RE: Drainage Study Update
Dutch Bros Coffee – NV3014
8570 Lake Mead Boulevard, Las Vegas, Nevada 89128
Our Job No. 22625

PROJECT South Shores Center

SUBMITTAL 1st. submittal- Drainage Study

South Shores Center Drainage Study

NORTH ENTRANCE STREET
 Q100 = 31 CFS
 N = 0.016
 SLOPE = 0.018

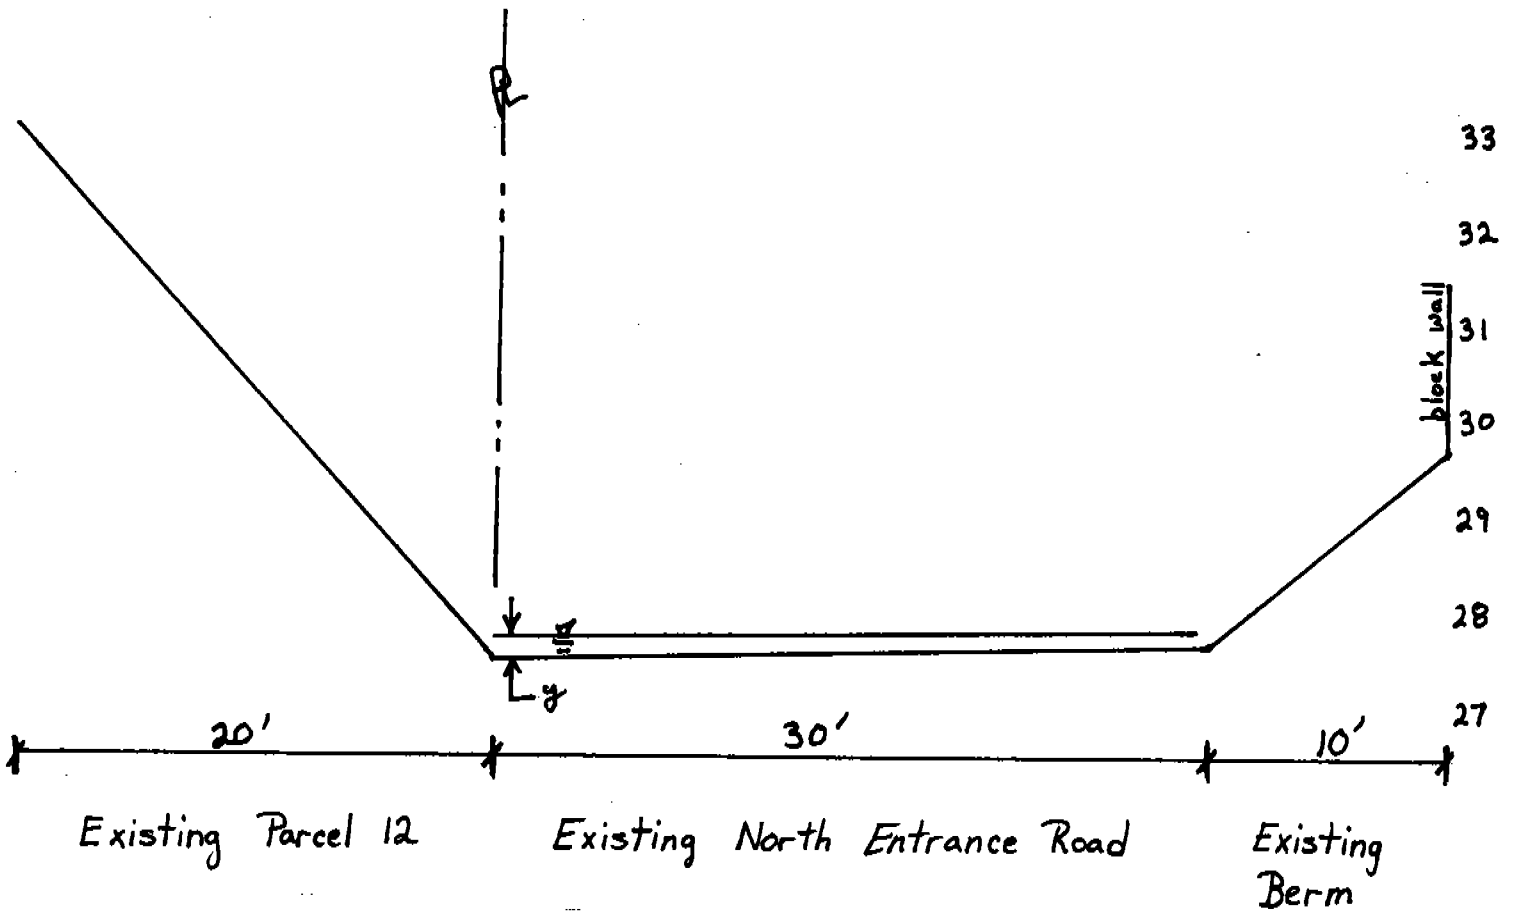
COMMENT 1B. Additionally, it appears from a field visit that off-site Basin B5 will also impact the site. Though the Wallace plan did not show flow from off-site Basin B5 being conveyed through the site a flow depth and flow cross-section must be provided along the west boundary of the site. The HEC-1 analysis must be adjusted to show flow from the west (or specific reference to the previous analysis, including xeroxes, provided).

The current routing of Wallace's Basin B5 is shown on the revised Drainage Plan included as part of this addendum. A cross section and flow depth of the North Entrance Road is also included with this addendum.
